Quad Trim Winding Interconnection on 21Q40 Half Cell Wiring Diagrams

Collider Accelerator Department
Brookhaven National Laboratory

BNL/SNS Technical Note
No. 136
R. F. Lambiase
June 2, 2004

Dwg 5300074

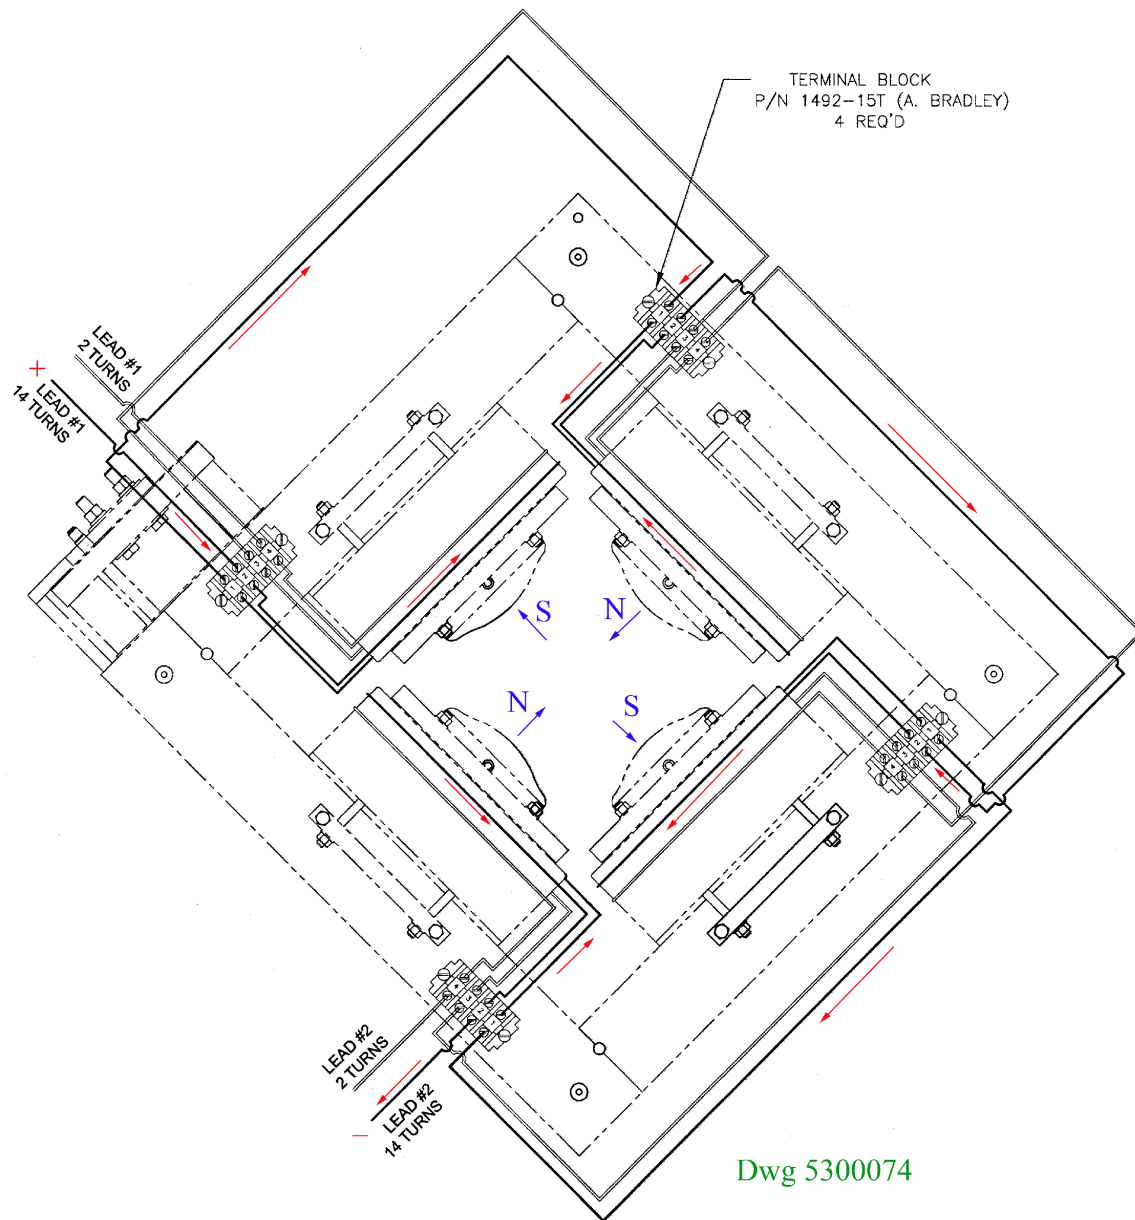
I have reviewed seven wiring diagrams, all relating to 21Q40 installations. The drawings are 5300 074, 081, 082, 086, 099, 100, and 129. The trim wiring on all these drawings is correct for the depiction of the winding direction shown on the drawings.

With a correct interconnection, a positive current entering terminal 1 will produce an “A” Polarity. I checked the drawings by marking up the relevant portion of each. The results are attached as a reference.
